August 15, 2023 Business Meeting Memo

SPR-22-0133: Gravante Residence

Site Plan Review to deconstruct the existing 2,498 sq. ft. residence before Request:

This letter certifies that in accordance with section 4-800 of the Boulder County Land Use Code, the Boulder County CPP Director has Approved with Conditions the site plan for the following, effective July 31, 2023.

Figure 1: Detail view of the Baseline Heights subdivision, subject parcel outlined in dashed red. Amongst others, the parcels located at 6686 Lakeview Drive (green star) and 6610 Lakeview Drive (purple star) are adjacent.

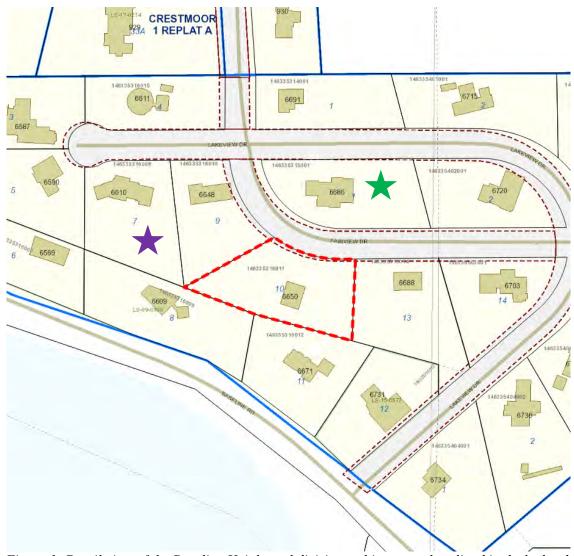
Following issuance of the Determination Letter, staff received a comment from a nearby property owner expressing concern that the approved size of the residence exceeded the presumptive size maximum and was out of character with the existing residences in the neighborhood. The commenter also stated that the floor area data being used by CPP was inaccurate, because the commenter's residence was shown as being 4,190 square feet on a size analysis report submitted with the application materials, and the commenter claimed that their residence was only 3,500 square feet.

As discussed in the Determination Letter, the approved size in excess of the presumptive size maximum was predicated on Article 4-806.A.2.b.i.b, which may allow applicants to overcome the presumptive size maximum when their property is adjacent to two other properties that are already over the presumptive size maximum. As defined in Article 18-102 of the Code, "Adjacent" means "Meeting or touching at some point, or across a street, alley, or other ROW". As shown in Figures 1 and 2, below, the parcel is currently adjacent to two parcels whose residential floor area already exceeds the presumptive size maximum.

Figure 2: Detail view of a neighborhood size analysis report for the subject parcel (outlined in dashed red) with parcels that exceed the presumptive size maximum indicated by orange shading. The adjacent parcels described in Figure 1 both exceed the presumptive size maximum of 4,530 sq. ft.

In an email exchange with the concerned commenter, staff also noted that the 4,190-square-foot total floor area shown on their property (visible in Figure 2, above, at the intersection of Lakeview Drive and Baseline Road) included all residential floor area as defined in Article 18-189D of the Code. The

| C0.0 | COVER SHEET |
|------|--|
| C1.0 | GRADING, REVEGETATION & EROSION CONTROL PLAN |

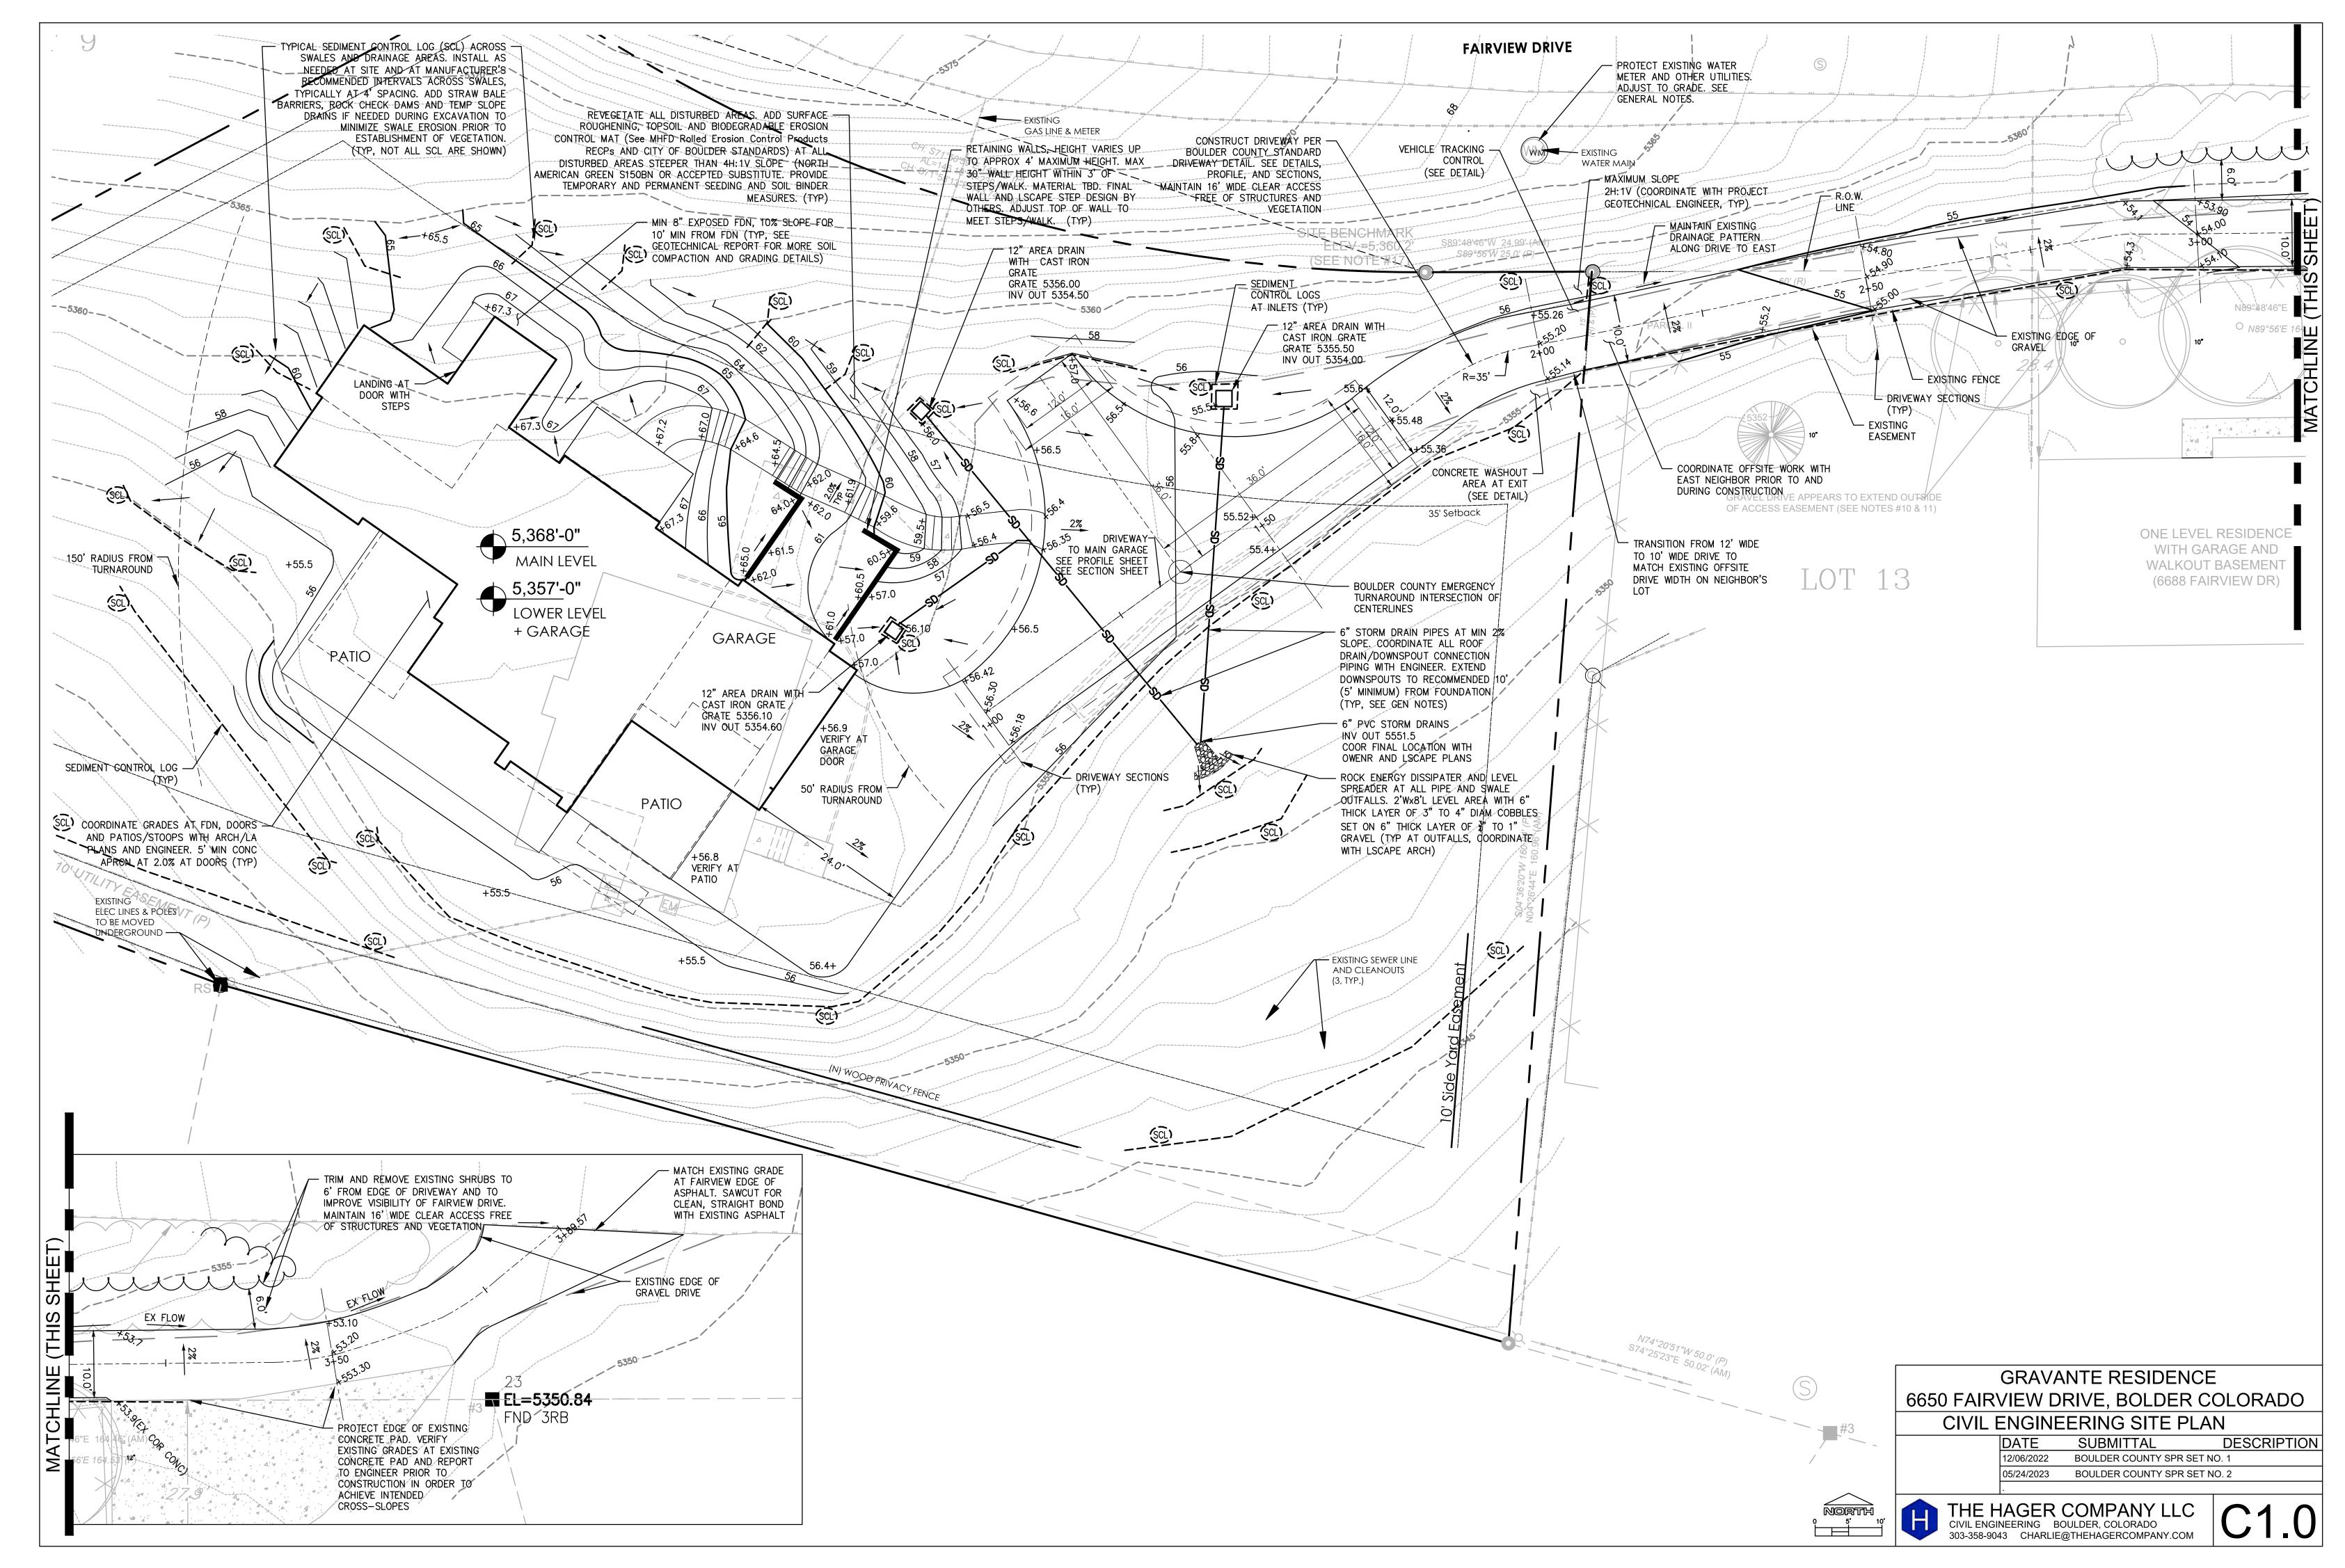
The grading plan provided by the Hager Company, dated 5/24/2023, indicates grading outside the access easement at approximately Station 2+25.

The application materials included a Civil Engineering Site Plan that briefly mentions revegetation of disturbed areas, but did not include the typical level of detail required for revegetation plans that meet county standards.

At building permit, provide proof of permission to grade out the access easement with an executed construction easement or other acceptable mechanism.

Prior to issuance of building or grading permits, submit to the Community Planning & Permitting Department for review and approval one copy of the proposed Revegetation Plan that conforms to the requirements as described on the materials located on our Revegetation Page.
